Bulletin

MODEL BENTLEY MARK VI

MODIFICATION.HORN PUSH BUTTON ASSEMBLY.

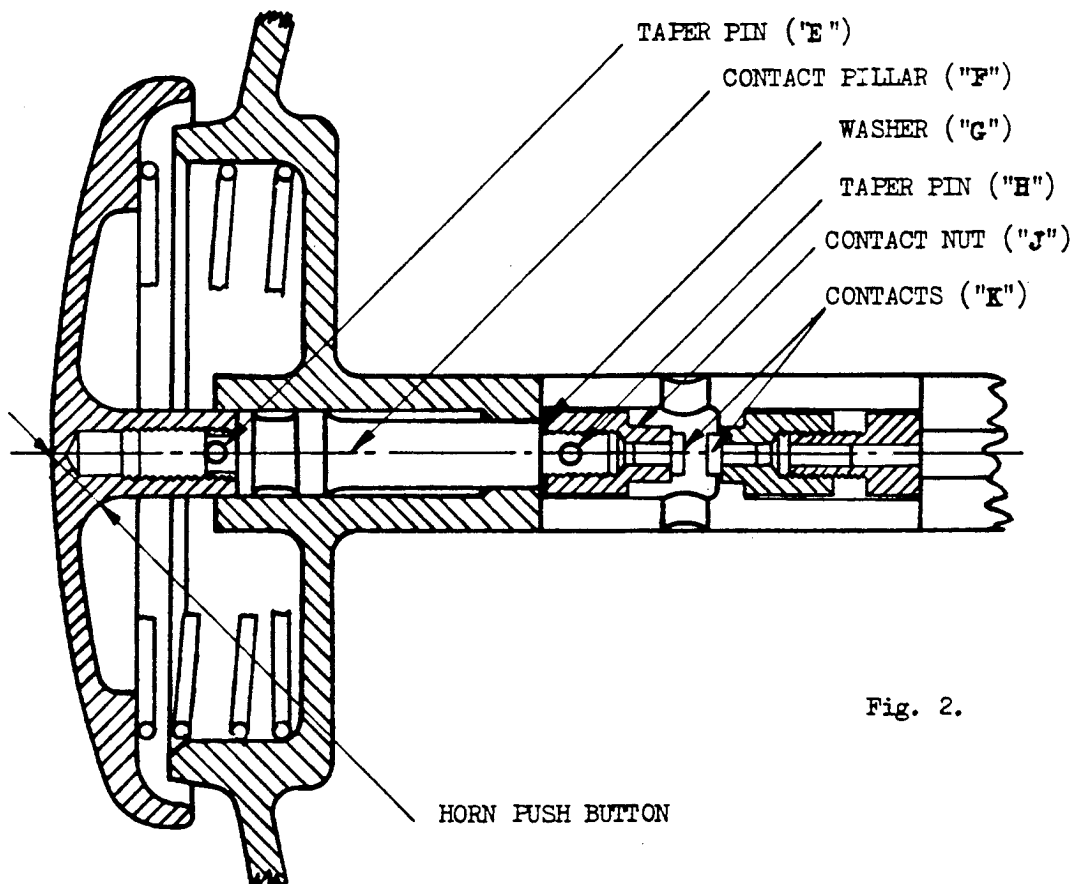
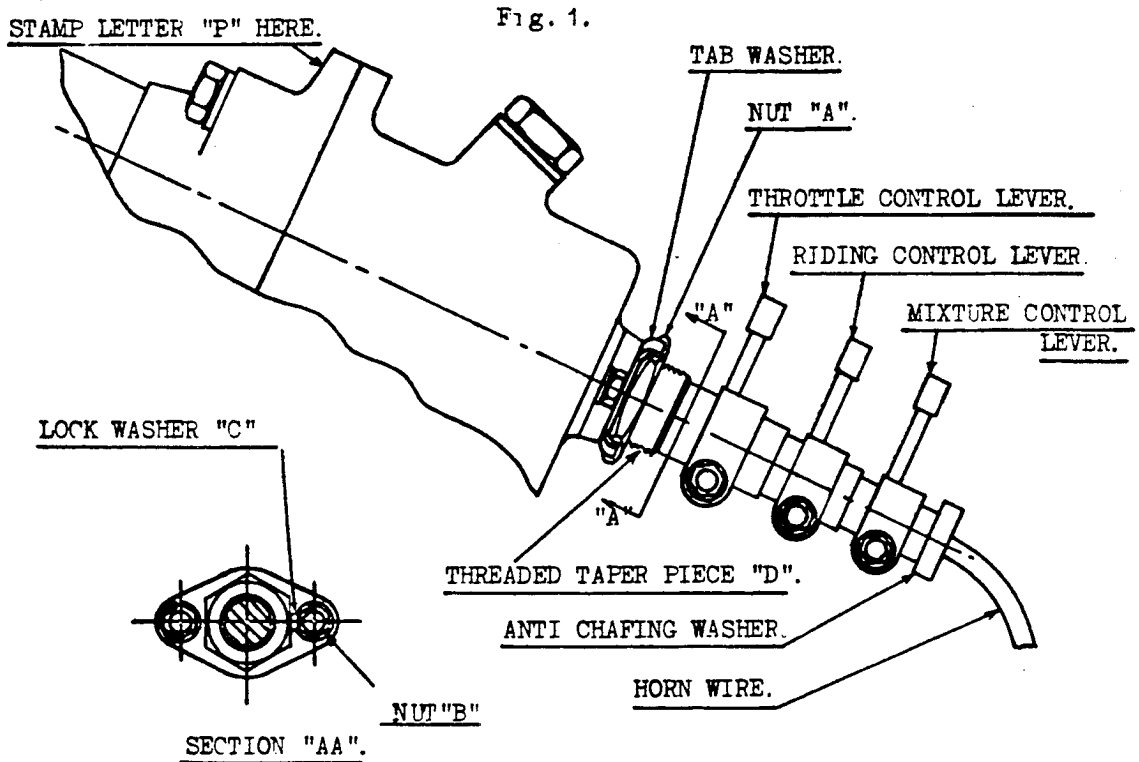
A modification is introduced to the horn push button assembly to give additional strength where the contact pillar is screwed into the horn push. The alteration consists of the substitution of the taper pin locking by sweating.

From the horn push button unit tap out the taper pin 'H' and remove the contact nut 'J' and the brass washer 'G'. The push button and its contact pillar 'F' is now free to be removed from its cover.

Tap out the taper pin 'E' from the contact pillar and unscrew the pillar from the button. This contact pillar, with holes drilled through both its threaded portions, and the taper pin 'E' can be discarded.

A new contact pillar, with its top threaded portion tinned with solder is screwed and sweated into the push button.

A distance of .040" between the contacts is desirable, and this is obtained as follows:-

Measure the distance with a stack of feeler gauges between the underside edge of the push button and the cover. Reduce the stack of feelers by .040", and when the button is pressed, the horn should start to sound just as the button nips the stack of feelers.

The amount of this travel is regulated by the thickness of the brass washer 'G'. If the horn sounds before the button nips the feelers, the brass washer requires reducing in thickness, but if a greater travel than .040" is obtained before the horn sounds, then a thicker washer is required.

When the correct amount of travel is obtained, the contact pillar is drilled through the existing holes of the contact nut 'J' and the taper pin 'H' fitted. The unit may now be finally refitted in the steering wheel hub.

Stamp the letter 'P' on the near-side lug of the steering box as indicated in the drawing.

MODIFICATION.CATEGORY: 3A.WINDSCREEN WIPERS - ELIMINATION OF NOISE.

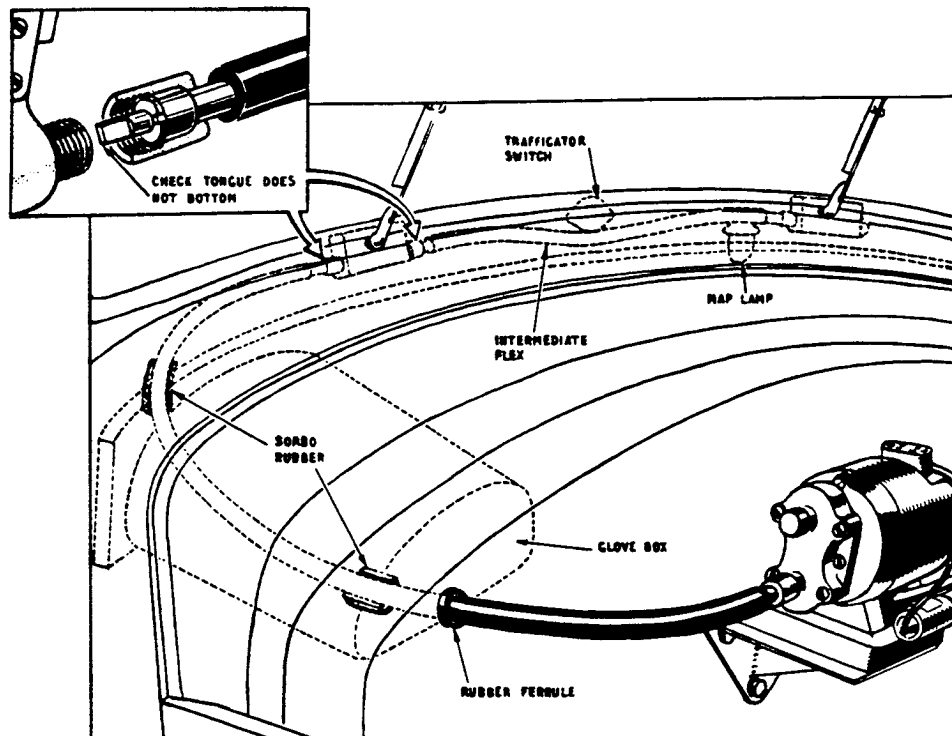
It has been found that noisy operation may be due to any of the following causes:-

- (a) Flexible drives fouling the scuttle rail or glove box.
- (b) Rigid attachment of the gearboxes to the scuttle rail.
- (c) Awkward bend in flexible drive or bottoming of tongues.
- (d) Noisy gearbox.

Having removed the screen finisher, switch on the wipers with the arms removed and listen for noise. Check that the flex does not foul at the points shown in the sketch and if necessary, add small pieces of sorbo rubber to prevent contact.

Slack off the gearbox fixing screws and see whether the noise is appreciably diminished. Rubber sheet in place of the felt mounting pad will be found to effect an improvement. The screws can be left only partially tightened with perfect safety.

If the noise persists, check that the driving tongues do not bottom in the slots; if necessary, shorten them by filing. Also make sure that the intermediate flexible drive is in the best position for lack of noise by slacking off the knurled nuts and twisting the outer flex to a new position.
